Report: TAB REPORT
Function: Test, Adjust, & Balance
Date: 07/16/2025
Completed By: National TAB

PROJECT
07-14-25 CHIPOTLE #5446 CHARDON, OH

Project: 07-14-25 CHIPOTLE #5446 CHARDON, OH

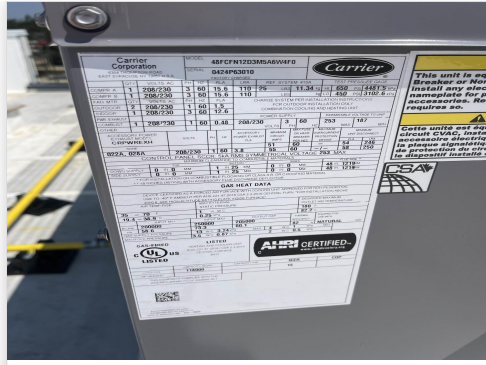
[1] DIFFUSERS SUM TO 4000 CFM. RTU SCHEDULE CALLS FOR 4400 CFM. PROPORTIONALLY INCREASED DIFFUSER VALUES TO MATCH RTU SCHEDULE. UNIT OPERATING AT 427 CFM/TON

[2] HIGHER THAN NORMAL NOISE FROM UNIT IN SPACE. SUSPECT INSTALLATION OF RTU DROP IS CAUSE, SEE ISSUE.
